Resolution authorizing a 12-month extension of a Wastewater Trunk Main Line Construction and Reimbursement Agreement for installation of a Wastewater Trunk Main Line and Lift Station with Braselton Custom Homes LTD for a planned residential development called London Towne located on CR-33

AMENDMENT OF WASTEWATER TRUNK MAIN LINE CONSTRUCTION AND REIMBURSEMENT AGREEMENT

Wastewater Trunk Main Line Extension Construction and Reimbursement Agreement amendment to Exhibit 3. Additional quantities added to original agreement.

EXHIBIT OF PROPOSED LONDON AREA MASTER PLAN WASTEWATER INFRASTRUCTURE

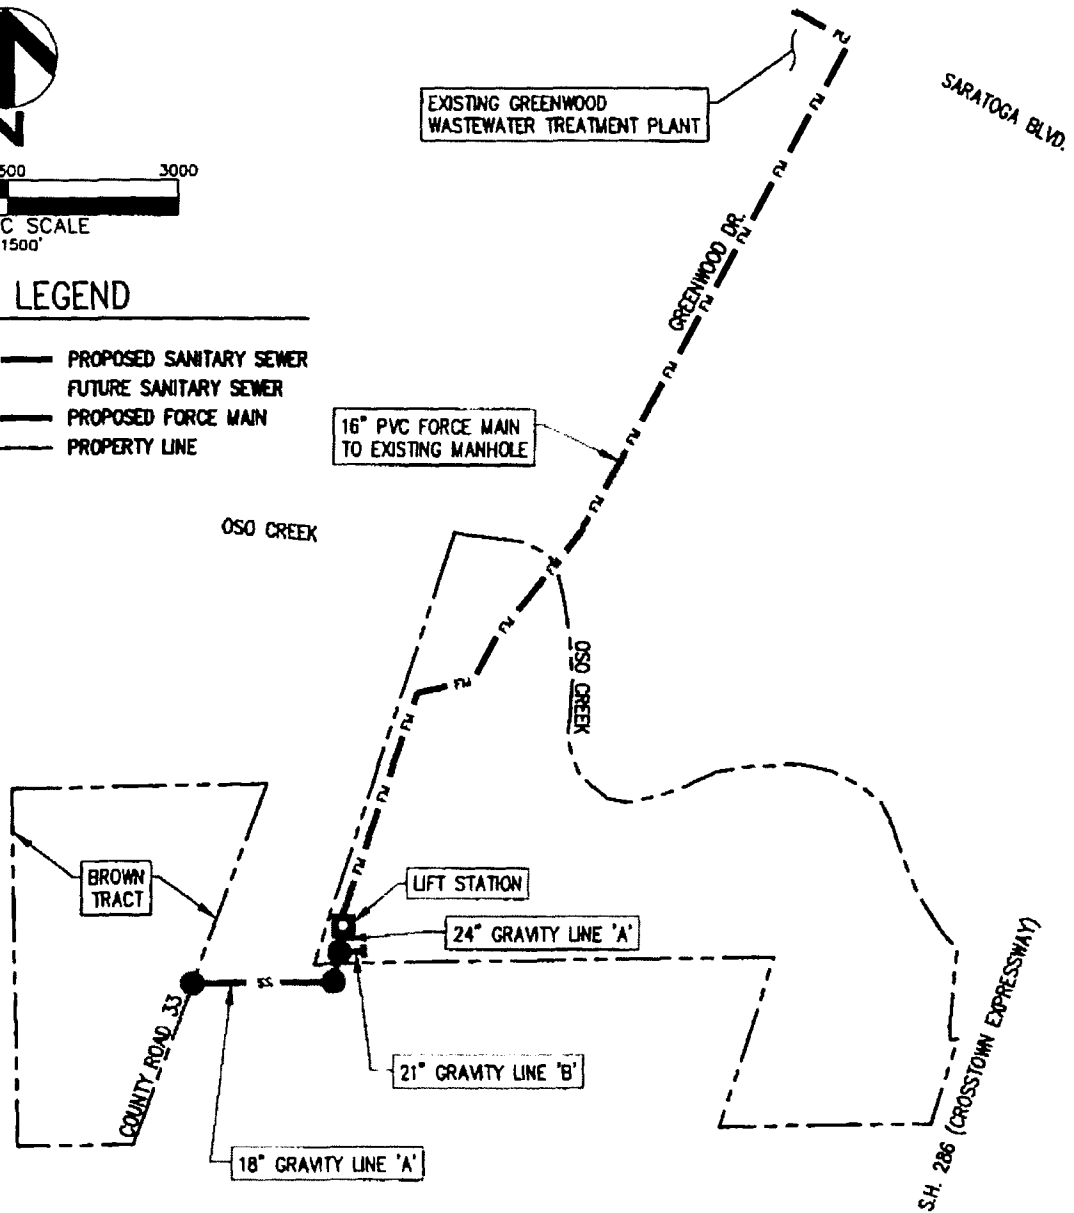
Note: This exhibit was revised per city request on March 27, 2018 to reflect a change in size of gravity sanitary sewer lines. The sizes shown on this revised exhibit are congruent with the sizes shown on the city's revised London master sanitary sewer plan which was presented to planning commission on 3/21/2018.
